Attachment A
Section 92 Response,
parts 1, 2, 3

Te Tupu Ngātahi
Supporting Growth
PO Box 105218
Auckland 1143

Attachment A: Section 92 response

Table 1: Proposed Flood Hazard Condition – changes since lodgement and rationale

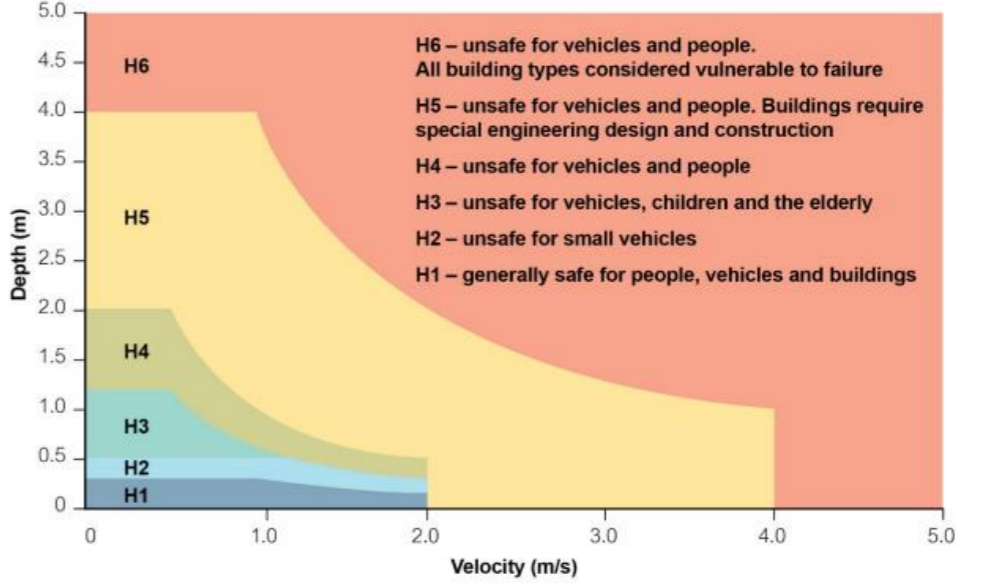
The table below sets out the Flood Hazard condition proposed at lodgment, the changes proposed as a result of a review of the condition carried out in December 2023 and our reasons for those changes.

Proposed Flood Hazard condition	Rationale for change from conditions as lodged
<p>For the purpose of the Flood Hazard condition:</p> <ul style="list-style-type: none"> (a) ARI – means Average Recurrence Interval. (b) AEP – Means Annual Exceedance Probability. (c) Existing authorised habitable floor – means the floor level of any room (floor) in a residential building which is authorised by building consent and exists at the time the outline plan is submitted, excluding a laundry, bathroom, toilet or any room used solely as an entrance hall, passageway or garage. (d) Flood prone area – means a potential ponding areas that may flood and commonly comprise of topographical depression areas. The areas can occur naturally or as a result of constructed features. Relies on a single culvert for drainage and does not have an overland flow path. (e) Maximum Probable Development – is the design case for consideration of future flows allowing for development within a catchment that takes into account the maximum impervious surface limits of the current zone or if the land is zoned Future Urban in the AUP, the probable level of development arising from zone changes. (f) Pre-Project development – means existing site condition prior to the Project (including existing buildings and roadways). (g) Post-Project development – means site condition after the Project has been completed (including existing and new buildings and roadways). 	<p>The change to c) makes the scope of the condition wider by allowing the condition to apply to buildings that were authorised before the Building Act came into effect.</p> <p>The change to d) provides some additional clarification and will be consistent with Auckland Council GIS definition of Flood prone area.</p>

Condition as lodged Sept 2023 (Appendix B, condition 10)	Proposed change to condition	Rationale for change from conditions as lodged
(a) The Project shall be designed to achieve the following flood risk outcomes:	The Project shall be designed to achieve the following flood risk outcomes:	N/A
<ul style="list-style-type: none"> i. no increase in flood levels in a 1% AEP event for existing authorised habitable floors that are already subject to flooding or have a freeboard less than 150mm; 	<ul style="list-style-type: none"> no increase in flood levels in a 1% AEP event for existing authorised habitable floors that are already subject to flooding or have a freeboard less than 150mm500mm; 	<p>A site assessment was carried out to estimate the amount of freeboard at buildings that might be affected by flooding close to the proposed NoR boundary (refer Section 4 and the maps in Appendix 1 of the Supplementary Flood Hazard Assessment). When the freeboard was estimated, the majority of those existing floors assessed were either flooded or within 150mm of flooding. Changing to 500mm had a minor increase in the number of floors subject to this condition but the controlling criteria was typically the building with freeboard less than 150mm.</p> <p>The new criteria also provides better protection for relatively new buildings that may be constructed prior to lodgement of the OPW– which is relevant to NoRs near flooding within the Future Urban Zone.</p> <p>Increasing freeboard to 500mm for these types of buildings aligns with freeboard standards in the AC Stormwater Code of Practice for new builds.</p> <p>It is not intended to protect all future buildings – those constructed after the OPW are lodged are expected to set appropriate freeboard above the Post project flood level.</p>

<ul style="list-style-type: none"> ii. no more than a 10% reduction in freeboard in a 1% AEP event for existing authorised habitable floors with a freeboard over 150mm; 	<ul style="list-style-type: none"> no more than a 10% reduction in freeboard in a 1% AEP event for existing authorised habitable floors to maintain a minimum with a freeboard of over 150mm; 	<p>A percentage freeboard reduction is not needed if a freeboard of 500mm is utilised in criteria i.</p>

Condition as lodged Sept 2023 (Appendix B, condition 10)	Proposed change to condition	Rationale for change from conditions as lodged
iii. no increase in 1% AEP flood levels for existing authorised community, commercial and industrial building floors that are already subject to flooding;	no increase in 1% AEP flood levels for existing authorised community, commercial, industrial and network utility building floors that are already subject to flooding or have a freeboard of less than 300mm;	<p>This criterion has been introduced to address flood effects as these types of building are present in the Project area – such as east of SH1 (NoR4).</p> <p>Increasing the freeboard to 300mm for these types of buildings aligns with freeboard standards in the AC Stormwater Code of Practice for new builds.</p> <p>Given the potential town centre areas in the Future Urban Zone there is potential for more of them to be constructed prior to the lodgement of the OPW. The new criteria provides better protection for relatively new buildings.</p>
